Appendix S: Response to Comments

For Programmatic Environmental Impact Statement on Utility-Scale Onshore Wind Energy Facilities in Washington State

June 2025, Publication 25-06-003

Figure 1: High Benefit, Low Harm Land Available for Siting Solar Systems (Bozuwa, Mulvaney, Estevez, Karlsson, and Malhotra, 2024)

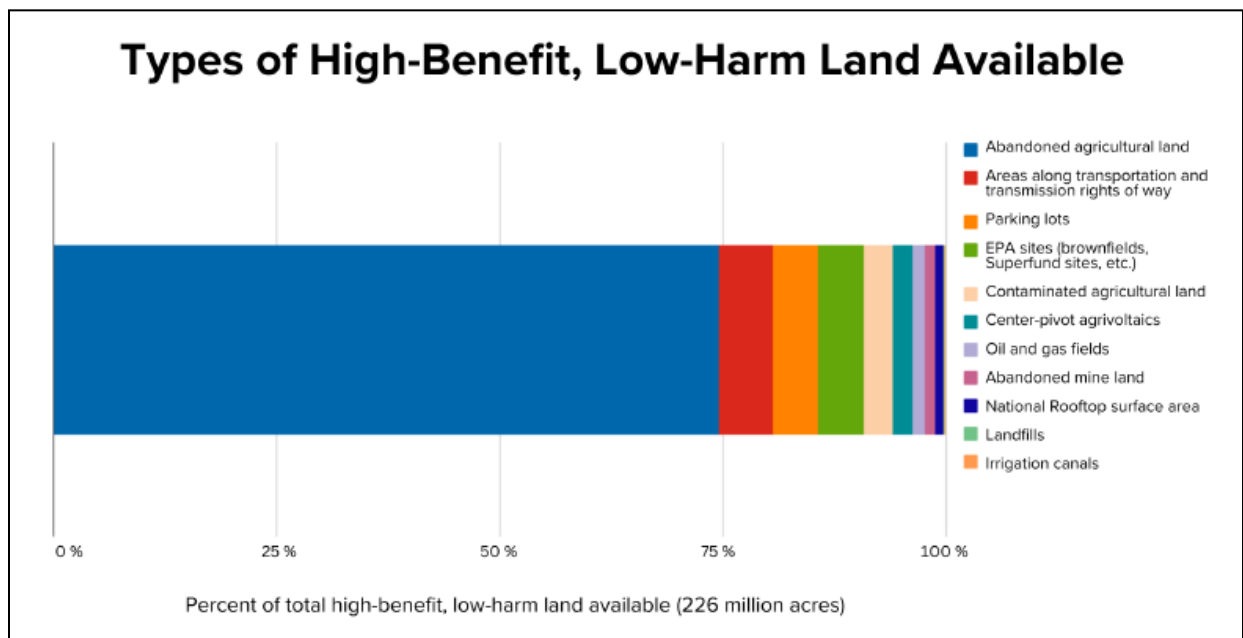
- 7 Adding solar panels to existing structures, like parking garages, warehouses, government buildings, shopping malls, and the like, also can feed electrons to the grid without taking valuable farm or ranch land out of production. Additionally, installing solar near the high demand areas of western Washington will reduce the need for costly upgrades to and energy losses associated with transmission lines across the Cascade Mountains. Indeed, in “Planning to Build Faster: A Solar Energy Case Study,” researchers from the Climate and Community Institute of the Roosevelt Institute recommend siting solar on abandoned agricultural lands, existing rights-of-way, parking lots, superfund sites, and the like, as shown in the figure below.⁹

Accordingly, Sierra Club urges Ecology to expand the consideration of suitable spaces for utility-scale solar to include degraded lands for renewable energy development.

Figure 2: Relative Environmental Conservation Value of Lands on the Columbia Plateau (Washington State University Energy Program, 2023)

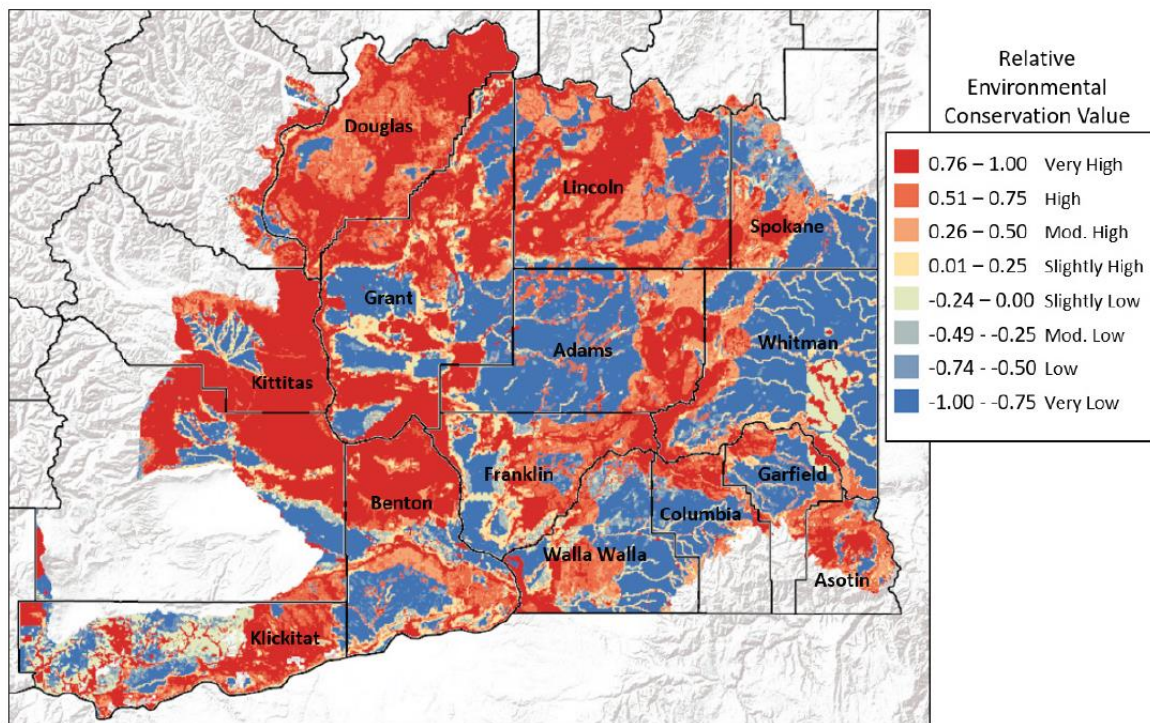
The Least Conflict Solar Siting Report and associated gateway provide similar maps for values of ranch and farmland, and a composite map that combines solar insolation information with data from the other maps. The gateway tool can also identify areas not used by wildlife, of low conservation value, not considered prime farm or ranchland, and thus more amenable to development for utility-scale solar. The information contained in the Report and gateway tool provide a more nuanced picture of the potential impact of utility-scale solar on the natural resources of Washington than the current PEIS and should be incorporated into the final PEIS.
